NORTHEAST NUCLEAR ENERGY COMPANY  
THE CONNECTICUT LIGHT AND POWER COMPANY  
THE WESTERN MASSACHUSETTS ELECTRIC COMPANY  
DOCKET NO. 50-336  
MILLSTONE NUCLEAR POWER STATION, UNIT NO. 2  
AMENDMENT TO FACILITY OPERATING LICENSE

Amendment No. 172  
License No. DPR-65

ATTACHMENT TO LICENSE AMENDMENT NO. 172

FIGURE 3.9-1A MINIMUM REQUIRED FUEL ASSEMBLY EXPOSURE AS A FUNCTION OF INITIAL ENRICHMENT TO PERMIT STORAGE IN REGION C

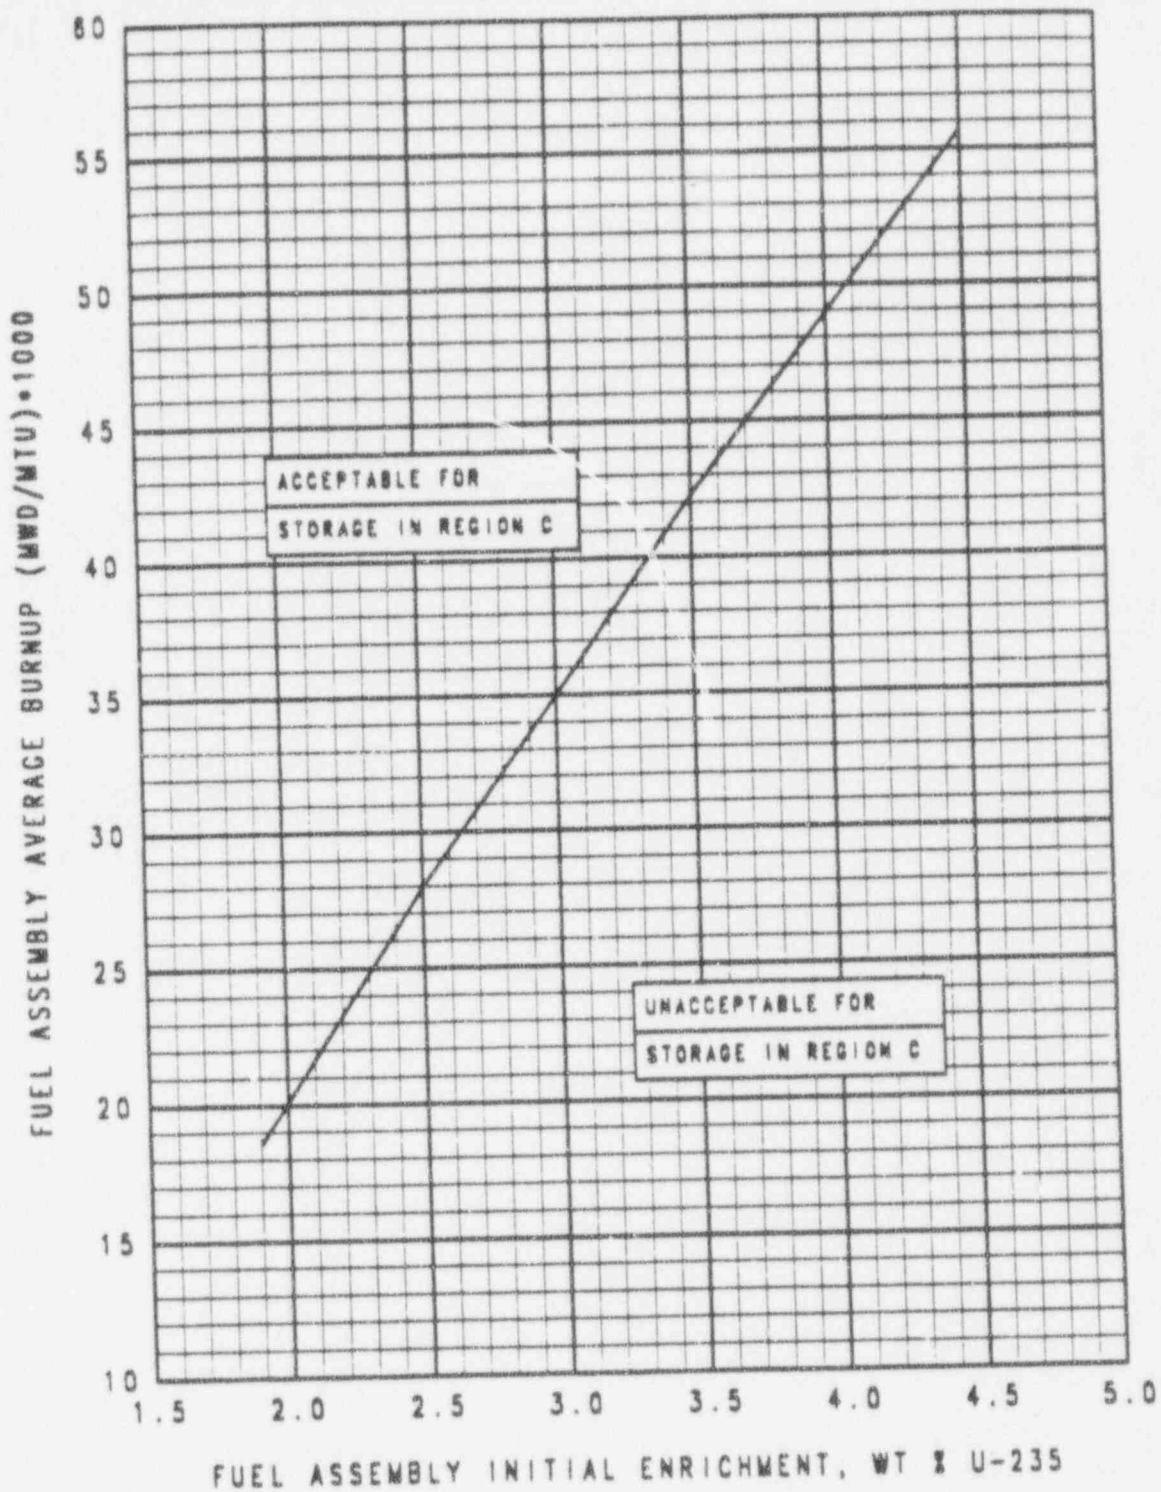
- (a) Fuel assembly enrichment and burnup are within the limits of Figure 3.9-1a by checking the assembly's design and burnup documentation; or
- (b) Fuel assembly enrichment and burnup are within the limits of Figure 3.9-1b by checking the assembly's design and burnup documentation, and borated stainless steel poison pins are installed in the assembly's center guide tube and in two diagonally opposite guide tubes.

SPENT FUEL POOL ARRANGEMENT  
FIGURE 3.9-2

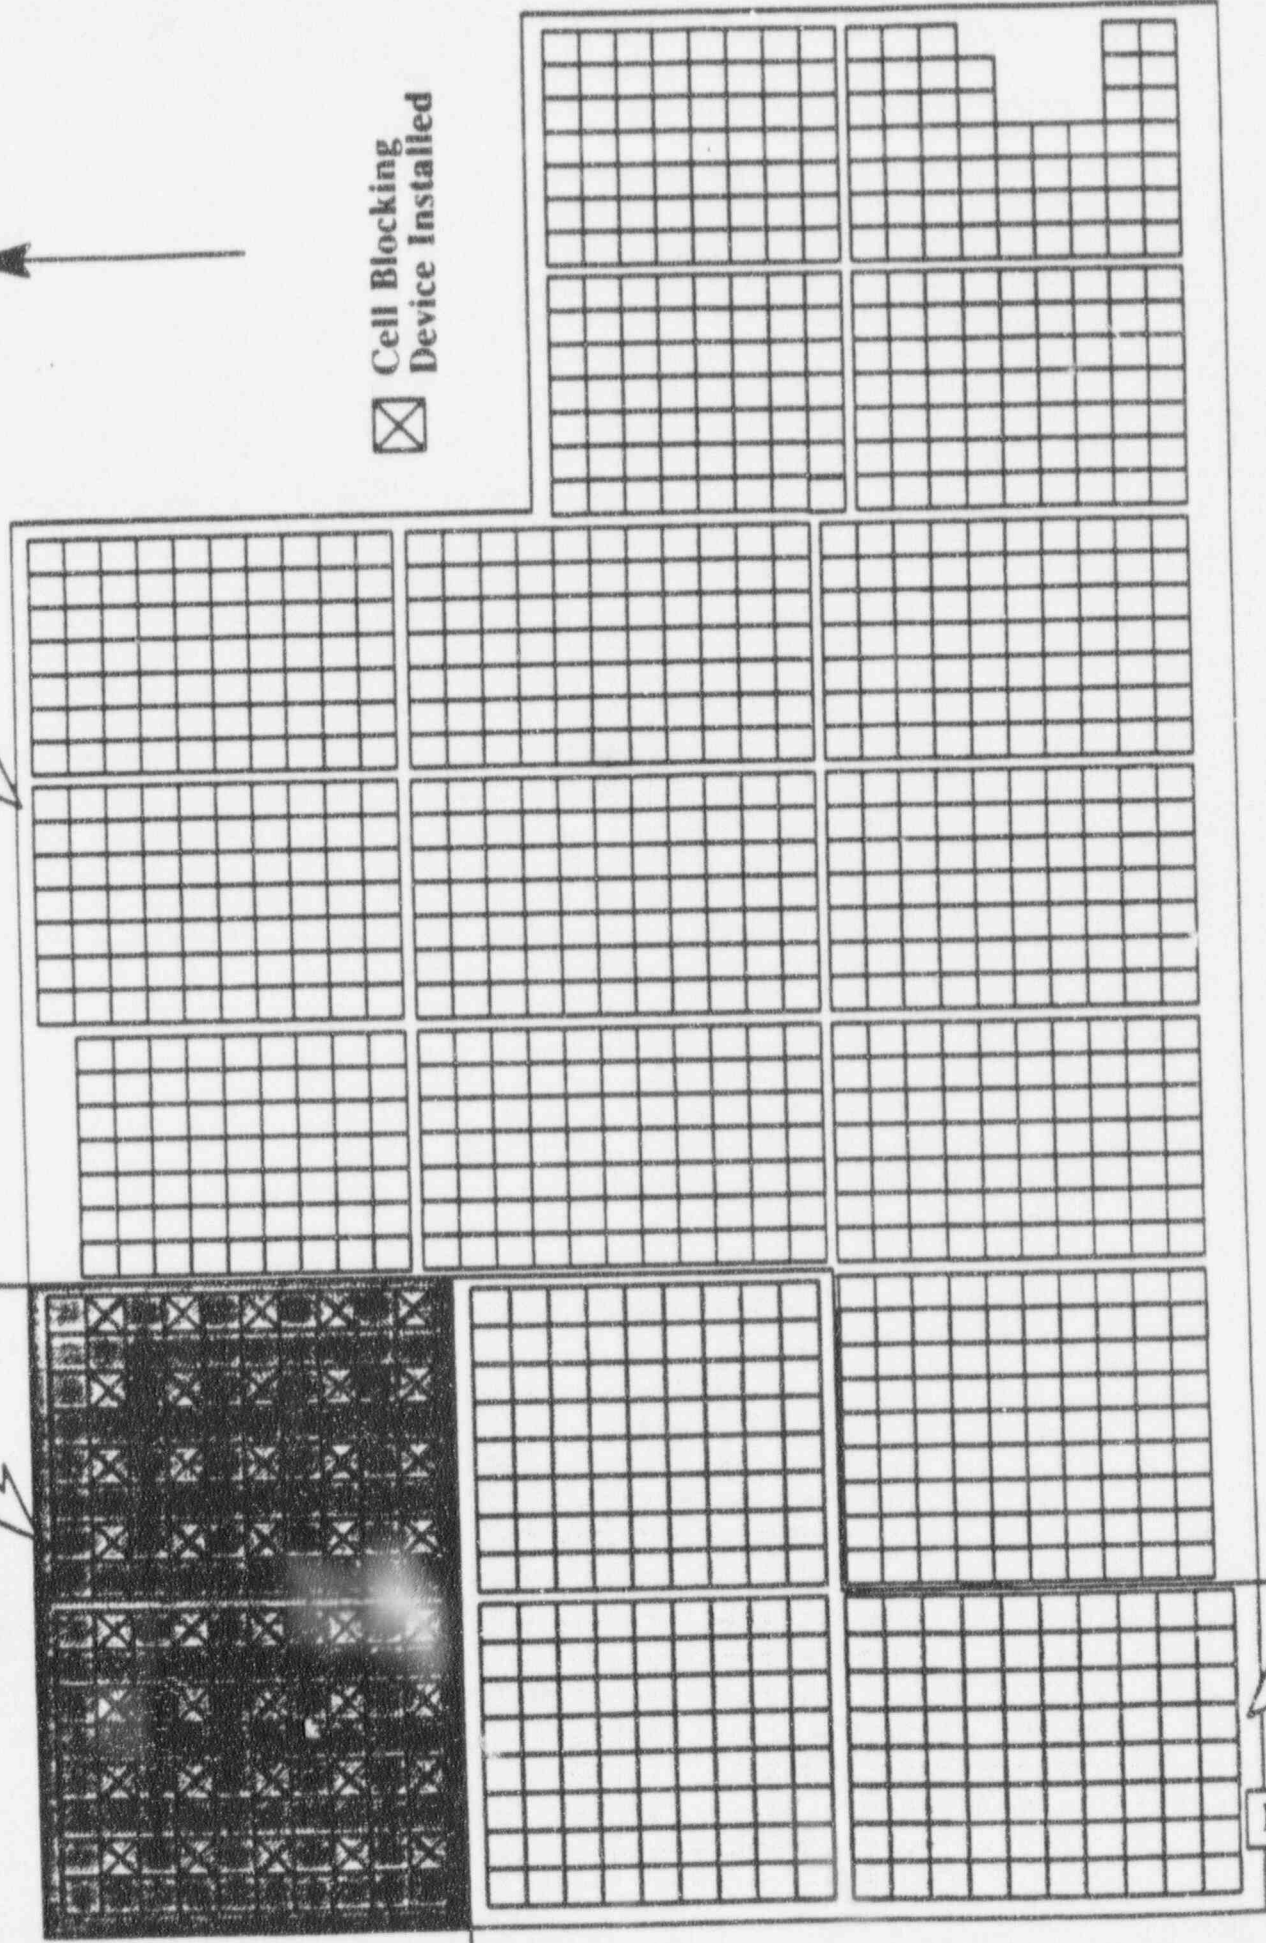
- (1) A cell blocking device is installed in those cell locations shown in Figure 3.9-2; or
- (2) If a cell blocking device has been removed, all cells in the STORAGE PATTERN must be vacant of stored fuel assemblies.
